HURRICANE CITY UTAH

Hurricane Planning Commission Meeting Agenda

April 23, 2026
6:00 PM

Agenda Date:	04/23/2026 - Planning Commission
Application Number:	PP26-06
Type of Application:	Preliminary Plat
Action Type:	Administrative
Applicant:	GA Homes
Agent:	Brigham McLaws
Request:	Preliminary Plat Approval
Location:	5150 W Sand Hollow Resort Parkway
Zoning:	R1-10(PDO)
General Plan Map:	Planned Community
Recommendation:	Approve subject to staff and JUC comments.
Report Prepared by:	Fred Resch III

CHECKED BY : SK
DRAWN BY : ADJ
DATE : 3/29/22
JOB NO. : 20-74
SCALE : 1"=20'
SHEET NO. : C-S1

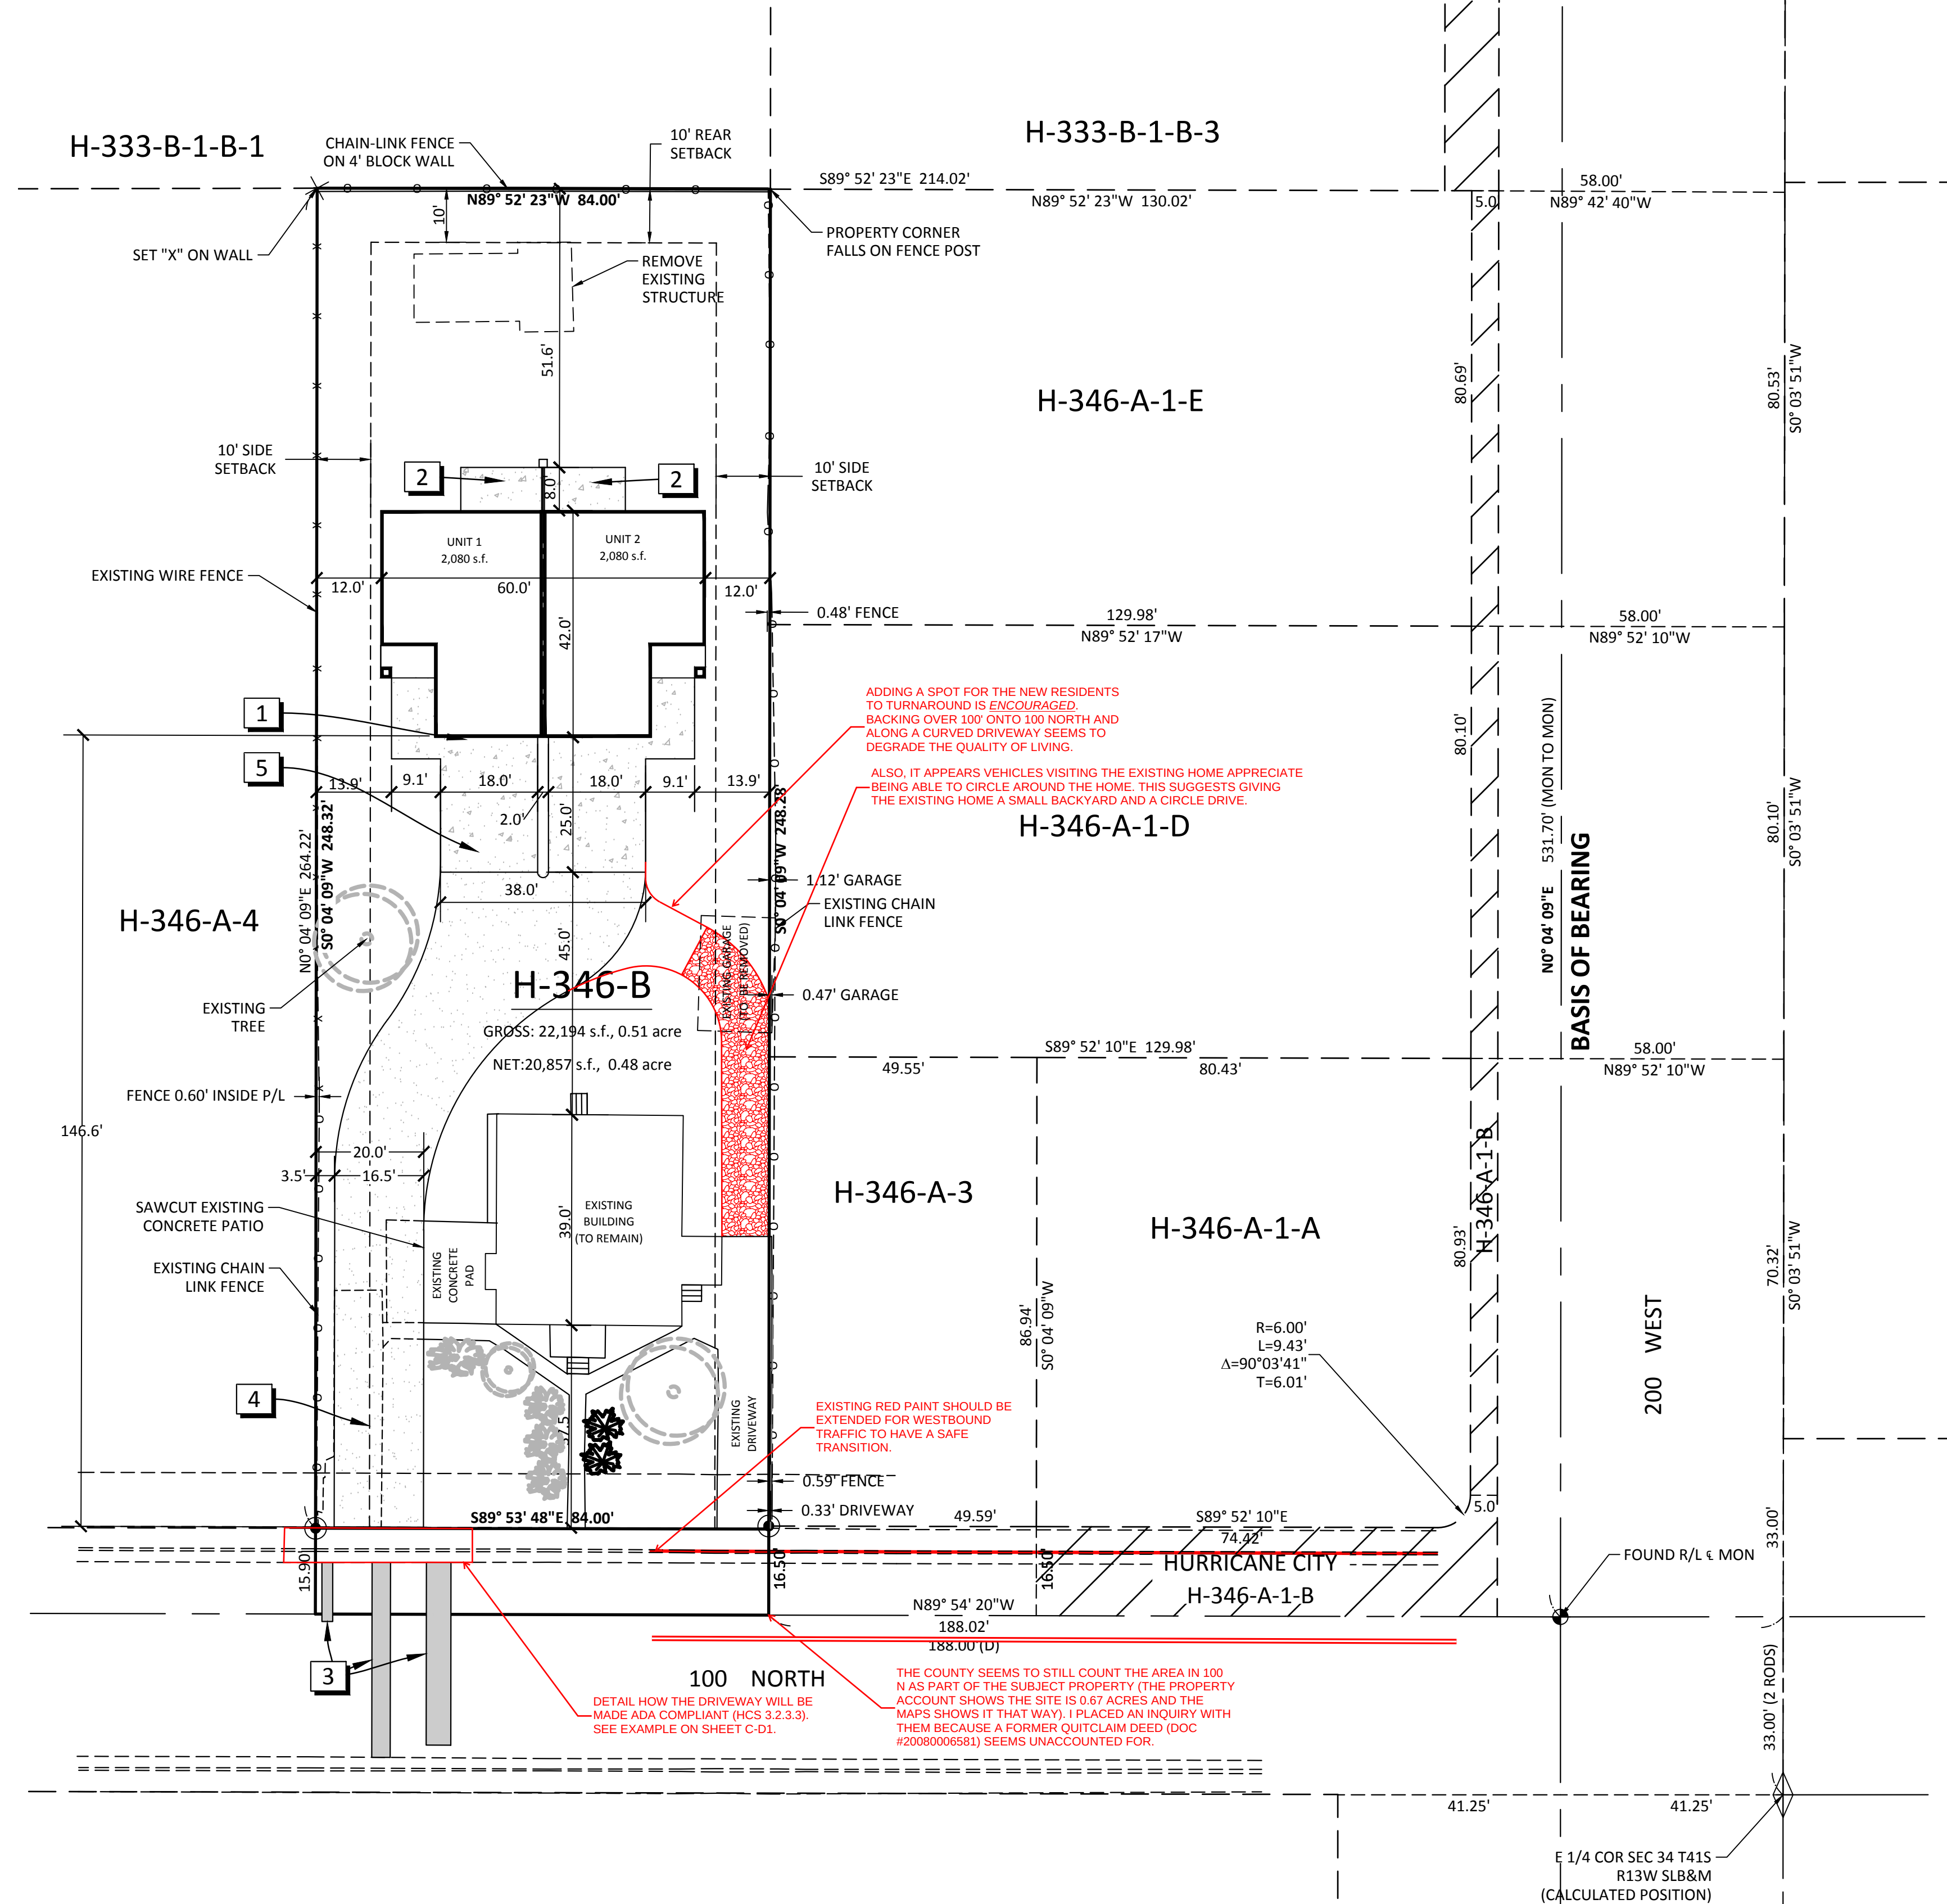
Note 1. Driveway approach must be ADA compliant.

Note 2. Unaccounted for 100 N City roadway property must be satisfied. (See Jeremy's comments on C-S1)
